TABLE OF CHANGES FOR PLANNING AMENDMENTS:
PLAN

Project Title
T2 VITA LIVING, ST. JOHNS

Drawing Title
**LEVEL 00
PROPOSED SITE PLAN**

Drawing Number
6555-P-B500-P-00-001

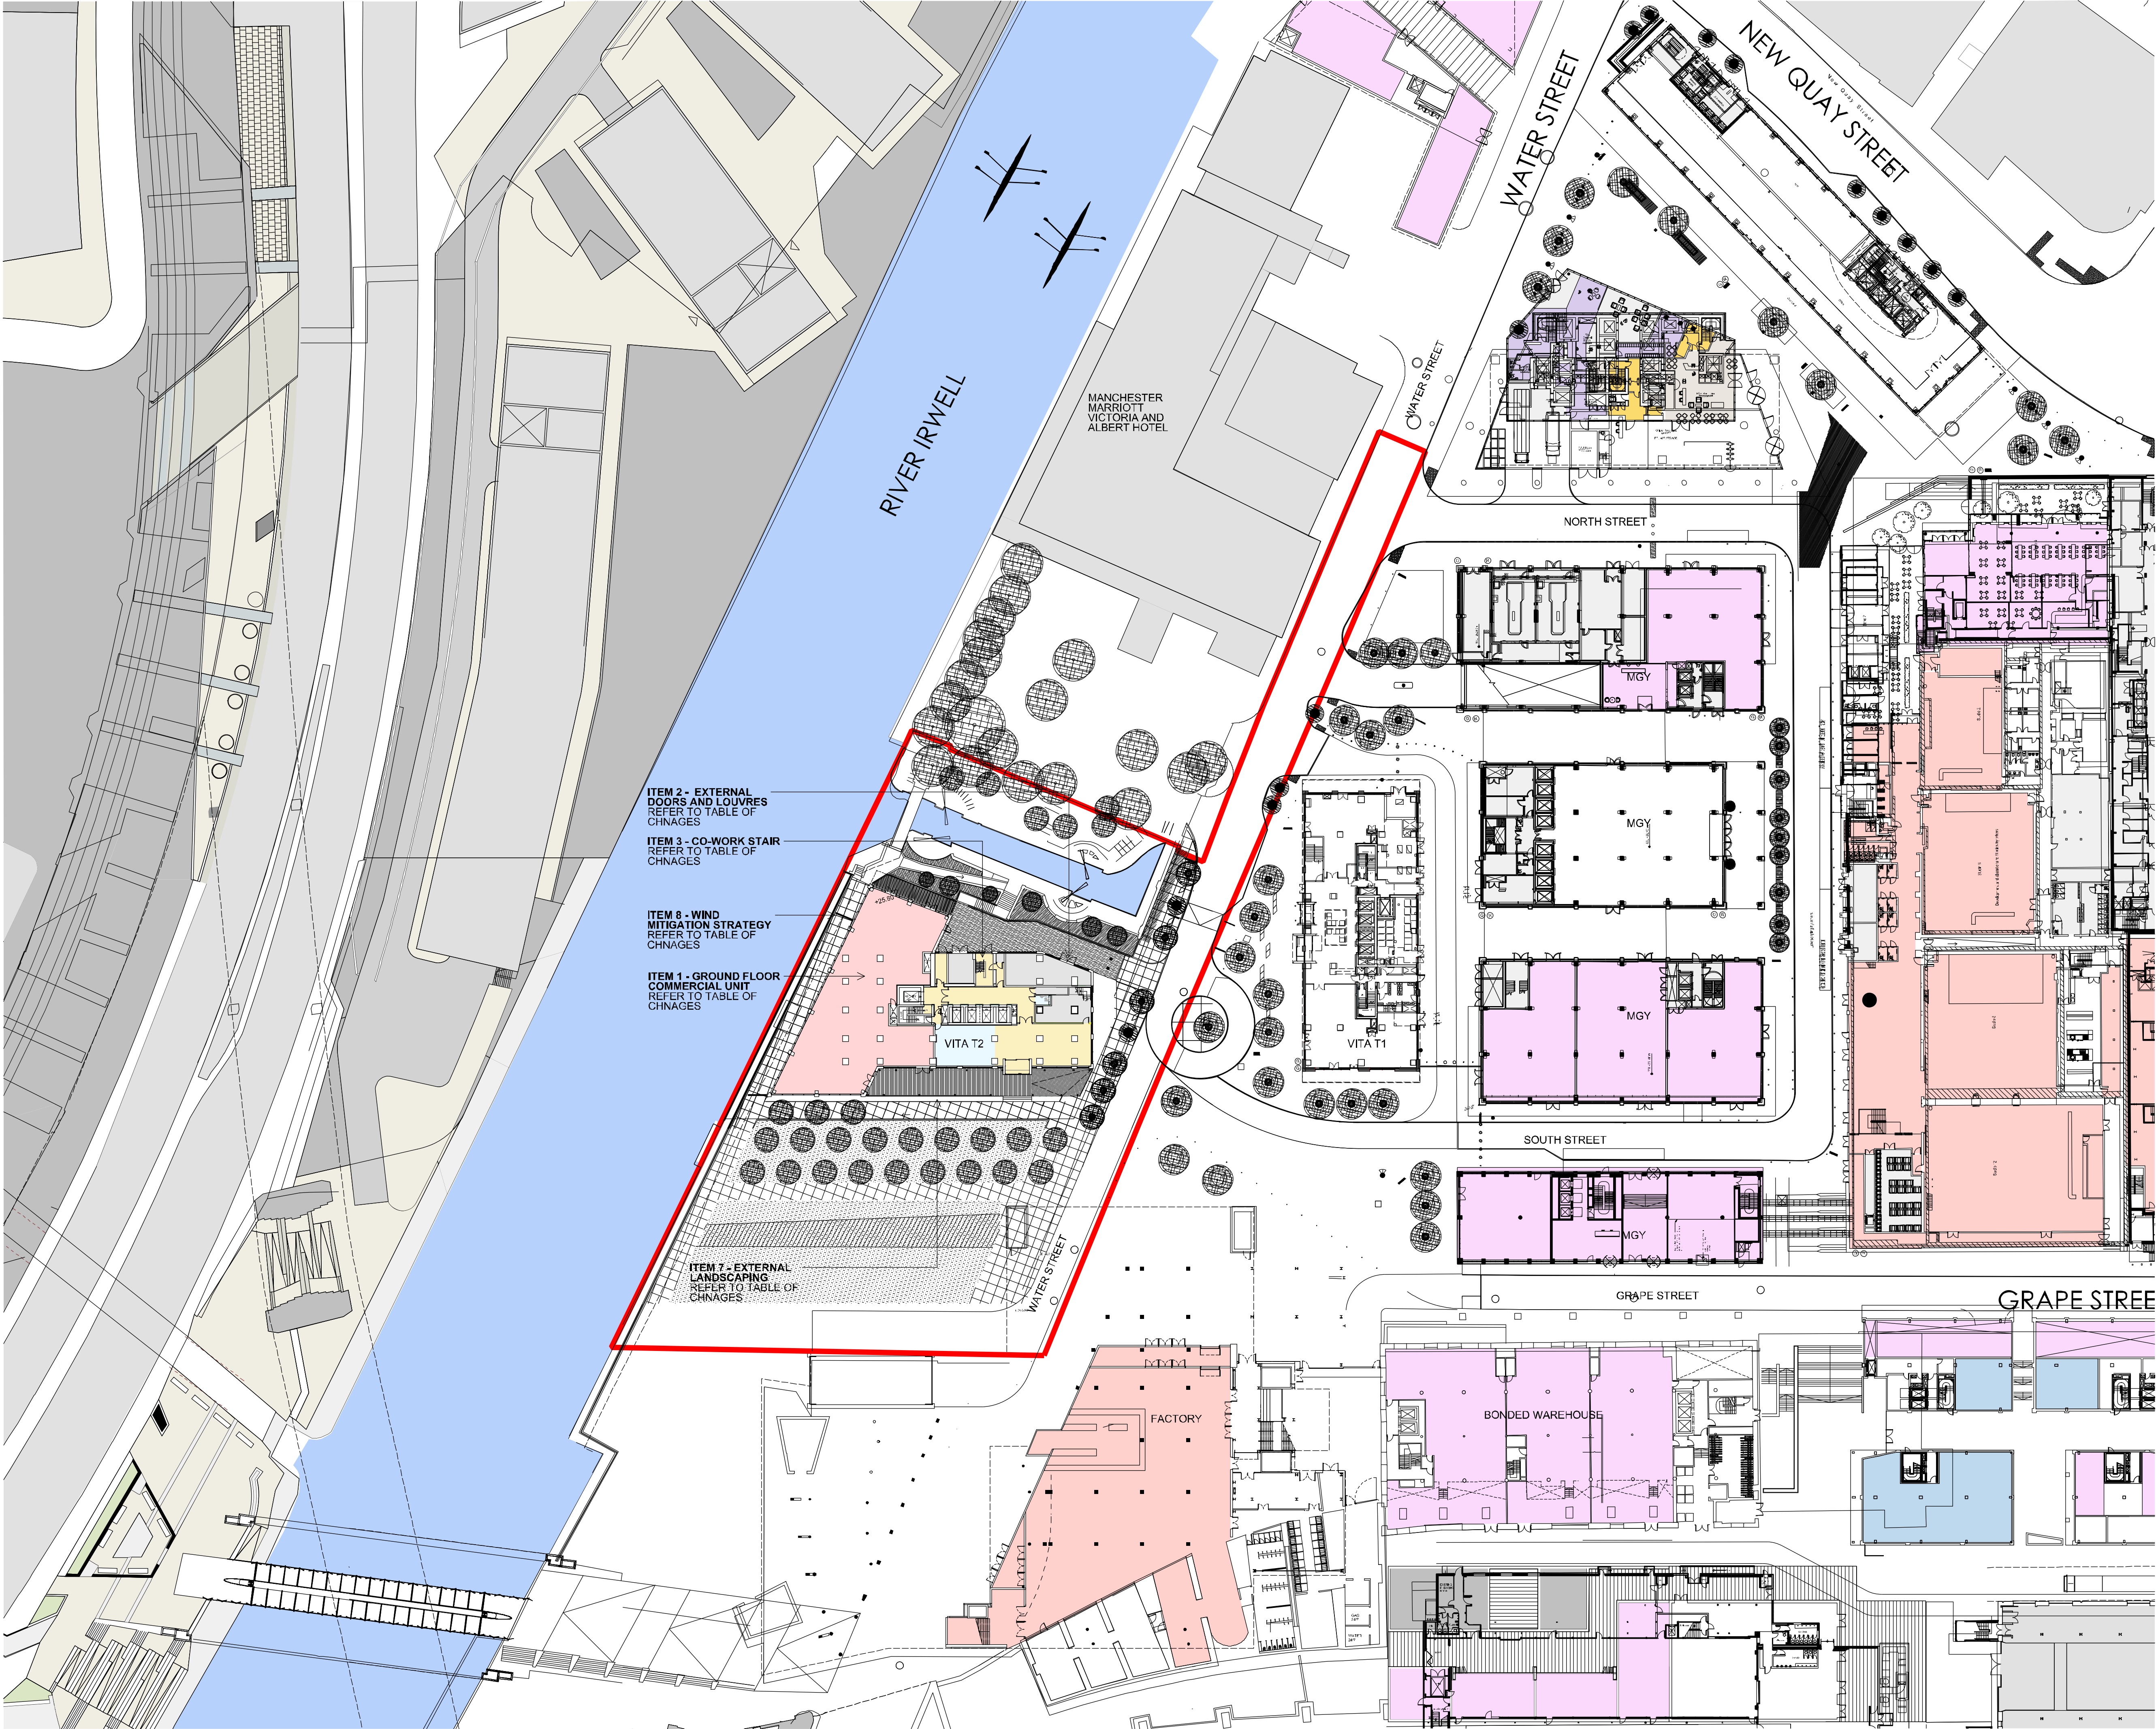
- 1 - GROUND FLOOR COMMERCIAL UNIT
GROUND FLOOR FOOTPRINT DEVELOPED TO
INCLUDE
COMMERCIAL UNIT
- 2 - EXTERNAL DOORS AND LOUVRES
INTRODUCED AND RECONFIGURED TO
GROUND
FLOOR AND MEZZANINE LEVEL

- 3 - CO WORKING STAIRCASE
NEW STAIR CASE INTRODUCED SERVING AS A
SECOND
MEANS OF ESCAPE
- 4 - BIN CHUTE
REMOVED AND REPLACED WITH INTERNAL
STORE
- 5 - BMU AMENDED
STATIC ROOF-MOUNTED MAINTENANCE UNIT
(BMU)
AMENDED TO MOBILE PERIMETER
TRACK-MOUNTED
TYPE BMU WHICH WHEN PARKED IS FULLY
CONCEALED

- 6 - INTERNAL PLANT
PLANT RECONFIGURED AT MEZZANINE LEVEL
INTRODUCTION OF NEW INTERNAL PLANT
ROOMS TO
LOWER ROOFLEVEL STAIR ACCESS TO UPPER
LEVEL ALSO INDICATED

- 7 - EXTERNAL LANDSCAPING
LANDSCAPING UPDATED TO ALIGN WITH
LATEST
PROPOSALS
- 8 - WIND MITIGATION STRATEGY
ADDITIONAL TREES, CANOPY, WALKWAY
ARCHES,
BALUSTRADES AND SCREENS INTRODUCED
FOLLOWING
WIND MITIGATION ANALYSIS

- 9 - ROOF TERRACE
INTRODUCED AT LEVEL 01 WITH GLAZED
PERIMETER BALUSTRADE
